ARKANSAS POWER & LIGHT COMPANY
POST OFFICE BOX 551 LITTLE ROCK, ARKANSAS 72203 (501) 371-4000
October 27, 1978

Subject: Arkansas Nuclear One - Unit 1
Docket No. 50-313
License No. DPR-51
ECCS Small Break Long-Term
Modification
(File: 1510, 0520)

MECHANICAL SOLUTION TO SMALL BREAK ECCS

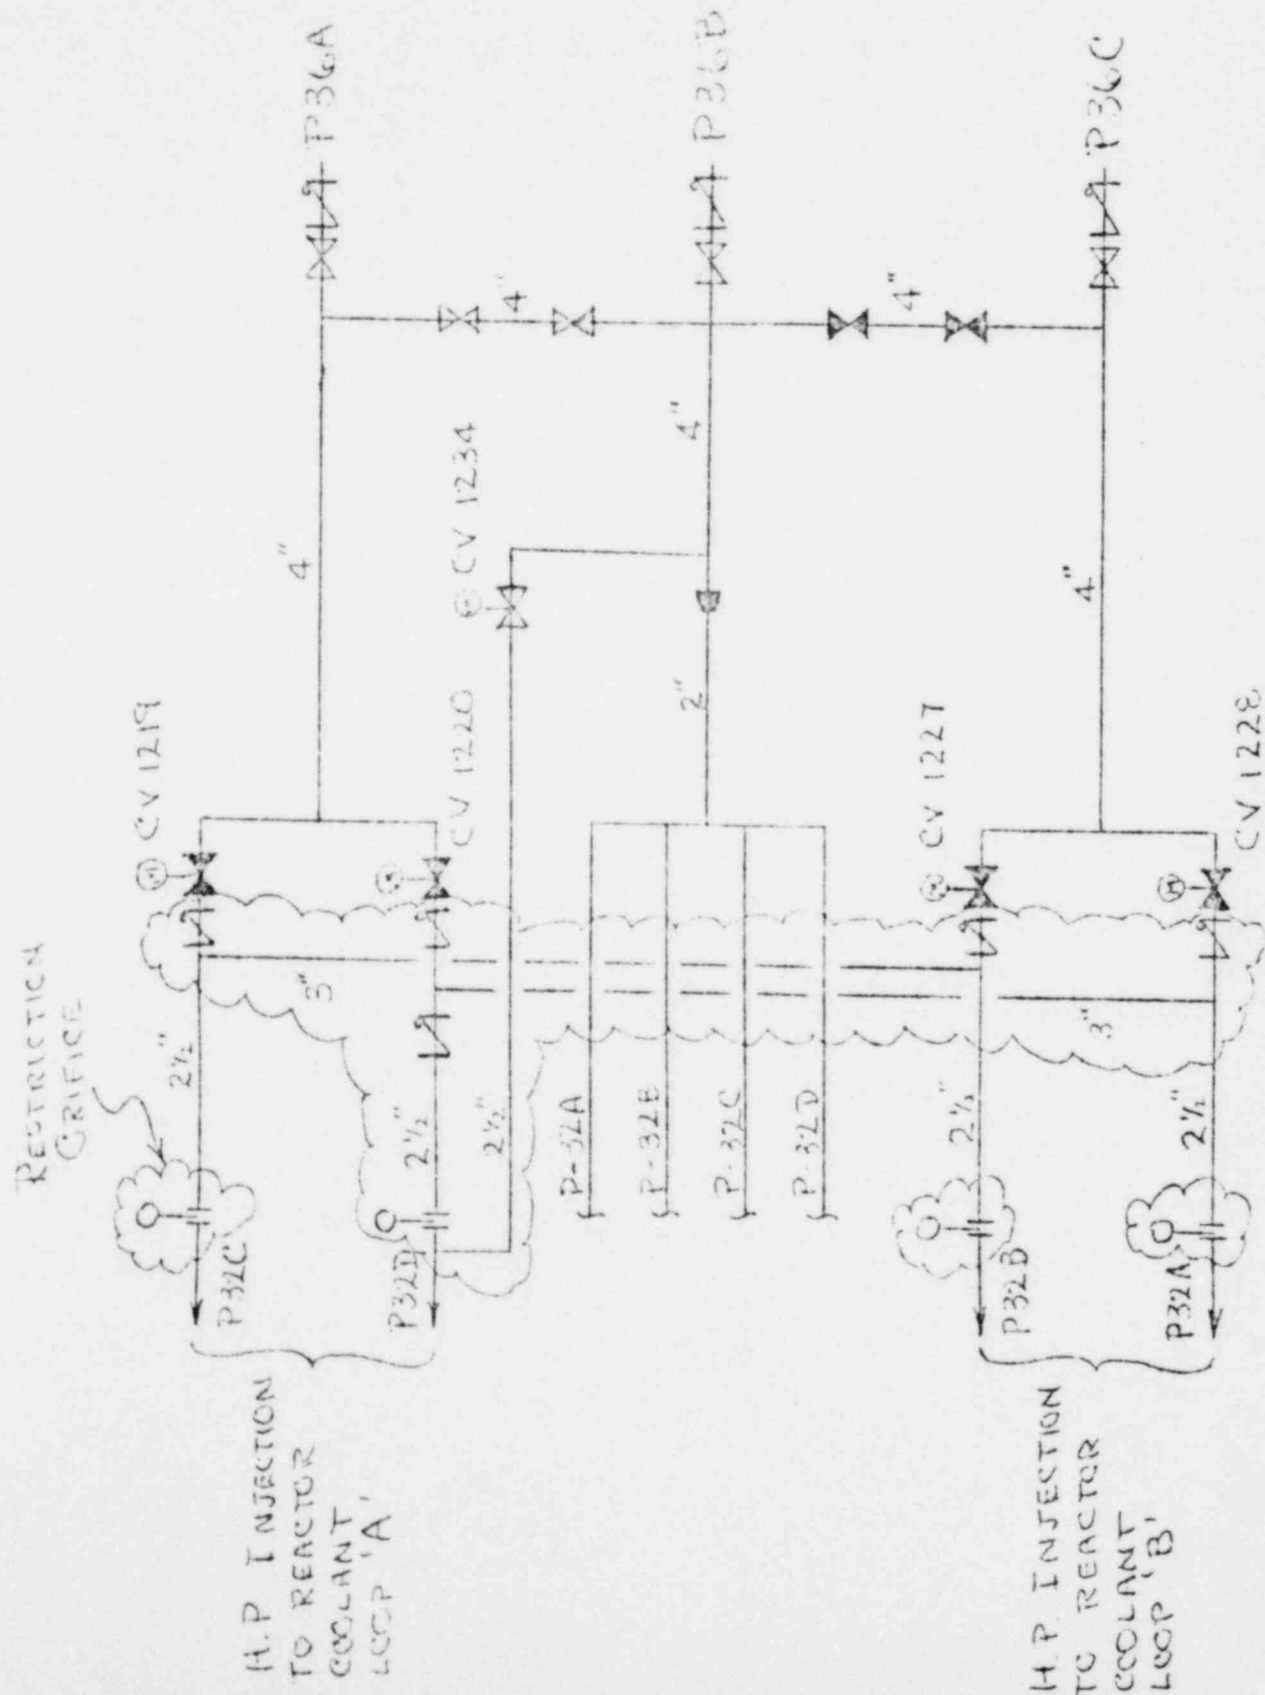
Attached is a diagram of the ANO-1 High Pressure Injection (HPI) system with the proposed modifications shown in bubbles. The modification consists of adding a 3" cross tie between HPI lines to P32A - P32D and P32B - P32C. Downstream of each of the cross ties are flow restriction orifices. These orifices will be sized such that equal flow balance in all four HPI lines is achieved and HPI pump run out is precluded.

Your letter of May 10, 1978, asked us to inform you if we utilized any throttle valves to obtain required flow distribution in the HPI systems. In response, the above modification will preclude throttling the HPI flow with valves as flow distribution will be achieved by the flow restricting orifices.
